Item Name: Fwd Crosstube - High 206L / L1 / L3 / L4

DART AEROSPACE LTD		Work Order: 140405
Description: Crosstube High Fwd (206L)		Part Number: D206-667-103
Inspection Dwg: D206-667-143	Rev: C	Page 1 of 1

DRAWING NO. D206-667-143	TITLE CROSSTUBE ASS'Y (206L HIGH FWD)	REV. C	DART AEROSPACE LTD ENGINEERING ORDER		D.E.O. NO. D206-667-143-C-1	SHEET NO. SHEET 1 OF 1	SCALE NTS
DRAWN 97	CHECKED AJS	MFG. APPR. JDS	APPROVED WD	DE APPR. H			
DATE 11.07.15	DATE 11.07.20	DATE 11.07.21	DATE 11/07/21	DATE 11.07.21

DRAWING NO. D206-667-143	TITLE CROSSTUBE ASS'Y (206L HIGH FWD)	REV. C	DART AEROSPACE LTD ENGINEERING ORDER	D.E.O. NO. D206-667-143-C-2	SHEET NO. SHEET 1 OF 1	SCALE NTS
DRAWN. AJS	CHECKED [Signature]	MFG. APPR. [Signature]	APPROVED [Signature]	DE APPR. [Signature]		
DATE 12.08.02	DATE 12.08.02	DATE 12.08.02	DATE 12.08.02	DATE 12.08.02	DATE 12-08-02

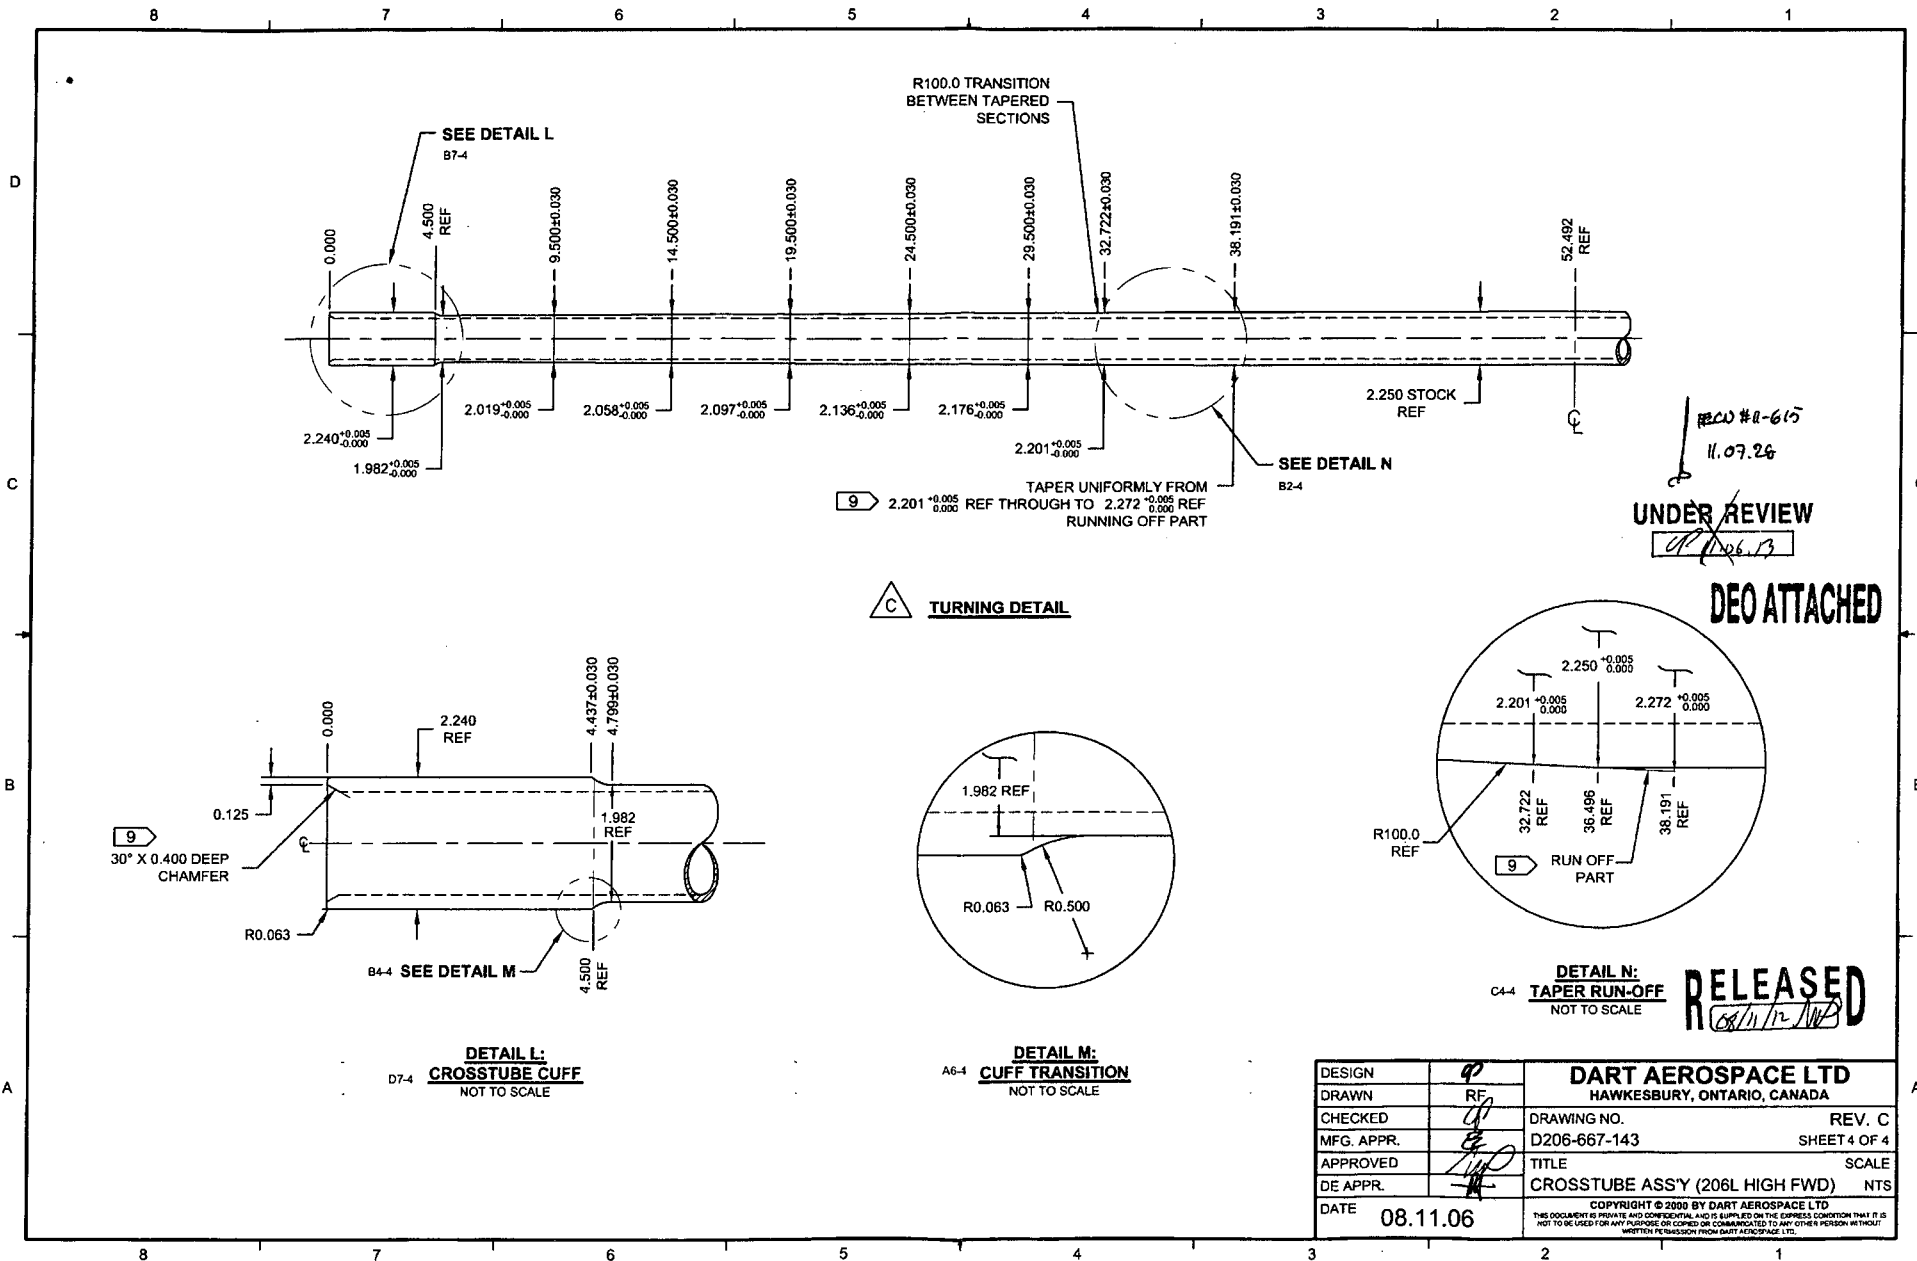
REPLACE MAGNOBOND WITH PROSEAL.

Item	Qty -143	Part Number	Description
9	A/R	PROSEAL 890 B-2	SEALANT, AMS-S-8802 CLASS B-2

9	A/R	MAGNOBOND 6398	ROCKWELL SPECIFICATION RBO-120-023 ADHESIVE (TEXTRON/BELL SPEC. 299-947-100, TYPE II, CLASS 2 ADHESIVE)
---	-----	----------------	---

NOTE 12 & 15, SHEET 1 IS AMENDED AS FOLLOWS:

- 12) TO INSTALL D2891-1 SUPPORT: ABRASE MATING SURFACE OF SUPPORT AND CROSSTUBE WITH 180-GRIT SANDPAPER AND REMOVE RESIDUE WITH MEK (OR EQUIVALENT). APPLY A 0.04" TO 0.07" THICK LAYER OF PROSEAL 890 CLASS B-2 (OR AMS-S-8802 CLASS B-2) SEALANT TO MATING SURFACE OF SUPPORT.
- 15) TORQUE CLAMPS 80 TO 100 IN-LB. ENSURE AT LEAST 1.5 THREADS SHOWING IN SAFETY AND THAT NUT HAS NOT BOTTOMED-OUT AFTER TORQUING. **PRIOR TO PACKAGING, RE-CHECK TORQUE ON CLAMPS AFTER PROSEAL 890 SEALANT HAS CURED FOR 72 HOURS.**

- 12) INSTALL D2891-1 SUPPORT USING 0.03" TO 0.06" THICK LAYER OF MAGNOBOND 6398 PER QSI 015. LET CURE FOR 12 HOURS AFTER INSTALLATION AND PRIOR TO PACKAGING.
- 15) TORQUE CLAMPS 80 TO 100 IN-LB. ENSURE AT LEAST 1.5 THREADS SHOWING IN SAFETY AND THAT NUT HAS NOT BOTTOMED-OUT AFTER TORQUING.

DETAIL P
BONDING STRAP INSTALLATION 2 PL

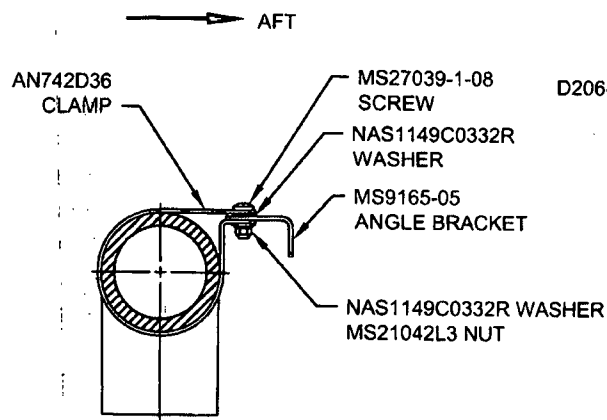
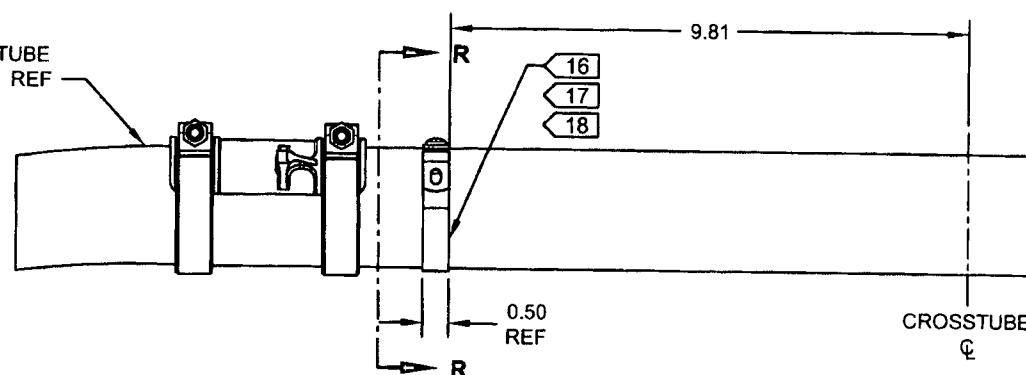
ADD ELECTRICAL GROUNDING STRAP

ITEM	QTY -143	PART NUMBER	DESCRIPTION
1	X	D206-667-143	CROSSTUBE ASSEMBLY (206L HIGH FWD)
10	2	AN742D36	CLAMP
11	2	MS9165-05	ANGLE BRACKET
12	2	MS21042L3	NUT (OR MS21042-3)
13	2	MS27039-1-08	SCREW
14	4	NAS1149C0332R	WASHER (OR AN960C10L)

- 16) MASK AREA UNDER CLAMP PRIOR TO PAINTING
- 17) SEAL EDGES WHERE AN742D36 CLAMP MEETS WITH THE CROSSTUBE USING SIKAFLEX-241/-291 OR MIL-S-8802 CLASS B2 OR PROSEAL 890 SEALANT
- 18) PERFORM RESISTANCE CHECK TO ENSURE MAX RESISTANCE IS 10 MILLIOHMS
